PIK/L3756-2/cam

12 October 2026

**RE: TECHNICAL PEER REVIEW OF HYDROLOGY/HYDROGEOLOGY JOINT
WITNESS STATEMENT - FOR FAST TRACK APPLICATION FTAA-2512-1153**

Project:
TAHAROA IRONSAND GROUNDWATER
EFFECTS ASSESSMENT - FTAA PANEL RESPONSE
Taharoa Ironsands Limited

FIGURE A

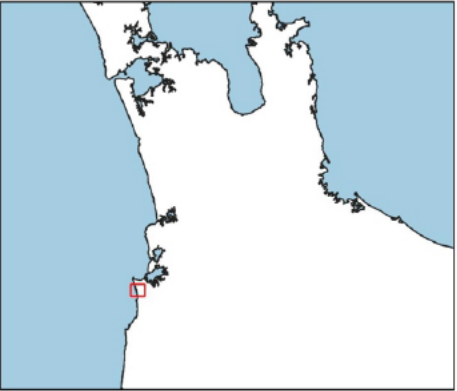
The WWLA Figures A1 to A6 are considered key to defining the maximum envelope of groundwater effects. For consent compliance, groundwater monitoring bores are proposed. The proposed bore locations together with coordinates are shown on attached Figure A and are summarised as follows:

i. Central Mine Pit

Two monitoring bores MBC1 and MBC2 located on western and eastern margins of mine extent.

ii. Southern Mine Pit

Three monitoring bores MBS1, MBS2 and MBS3 located on western, eastern and southern margins of mine extent.

For all bores, groundwater level triggers (in terms of mAMSL) would be based on the WWLA Figures A1 to A6 predictions. For compliance, continuous monitoring of groundwater levels using level loggers is recommended. This compliance monitoring would provide the primary means of ensuring that sand mine dewatering stays within the maximum consented drawdown envelope.
